Product Change Notification: PCN-23-176499

Superseal Connector Receptacle Contact Assembly

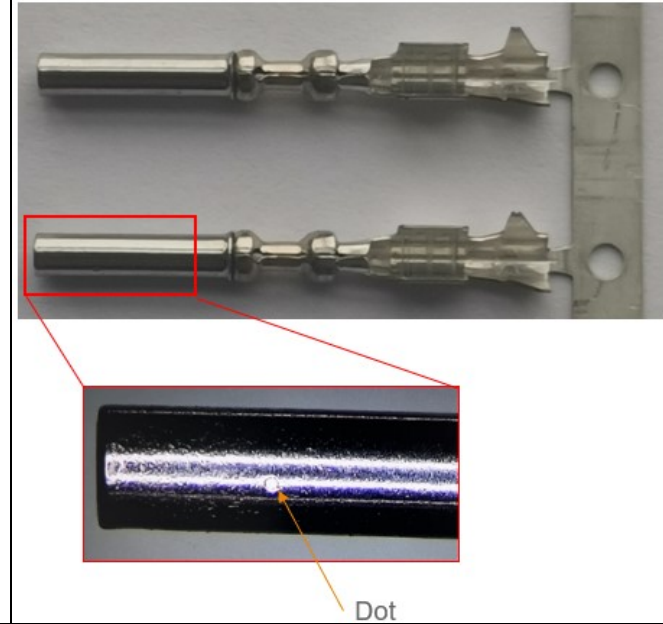
The Industrial and Commercial Transportation business unit of TE Connectivity is adding new capacity tooling for Superseal Connector Receptacle Contact Assembly at our existing factory in Suzhou, Jiangsu (China) for the part number(s) listed below. The material of socket body made in Suzhou is changed from beryllium copper to Cu-Ni-Si alloy which has very similar performance. The tin plating in crimp area of socket body made in Suzhou is changed from bright tin to matte tin. And a dot is added on sleeve for traceability. These PNs are TE proprietary designs, therefore considered as catalog/general market product. PPAP and/or sample requests must be submitted within 14 days of PCN submission via ict-ppap-request@te.com or ePPAP system. Submission will not occur without request. If PPAP requested, disposition response is required within 14 days of submit date or it will be considered approved. Product drawing(s) are not affected.

The new capacity tooling is necessary because of increase in global production demands. And the material change is necessary due to serious material shortage of beryllium copper. Matte tin in crimp area is adopted for plating standardization but no influence on performance. These changes do not impact terminal or connector performance.
